Missing Knobs and Screws?

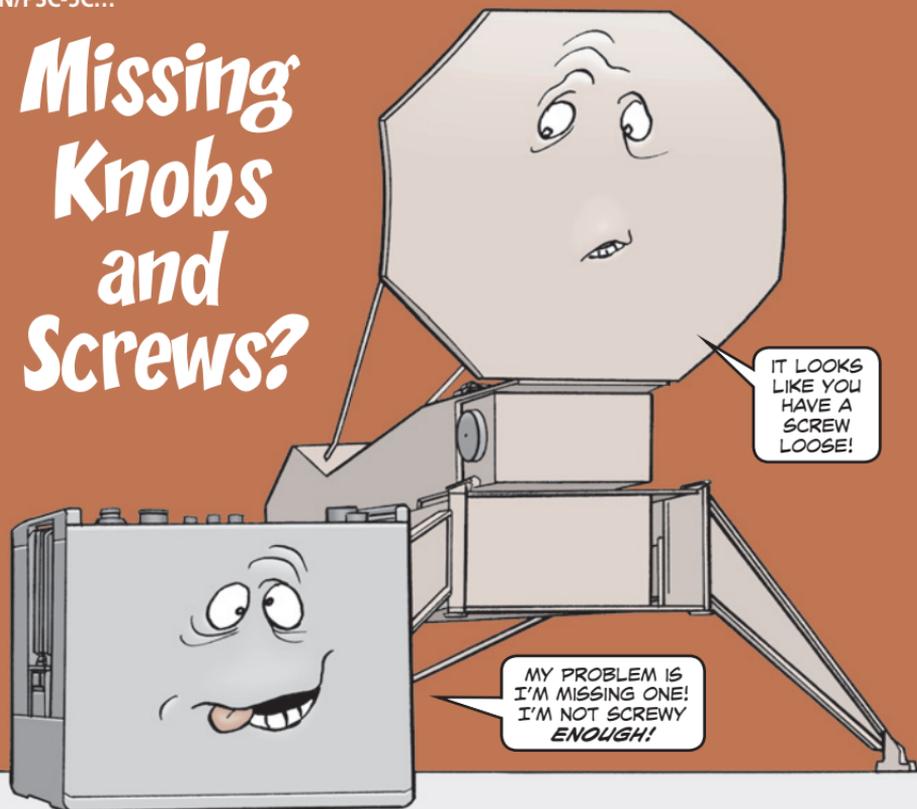
The three control knobs—squelch, dim and volume—on the AN/PSC-5C tactical satcom radio are each held in place by a setscrew. That setscrew is PN MS5-1021-21, NSN 5305-00-531-0137. It is not setscrew, PN130937-1, NSN 5305-01-512-1703. If you have anything that says it is—like the new manuals on the AN/PSC-5C—correct it.

If you're missing a knob, order a new one with NSN 5355-01-409-0798.

The right NSNs and part numbers are shown in Fig B-3 of TM 11-5820-1130-30&P.
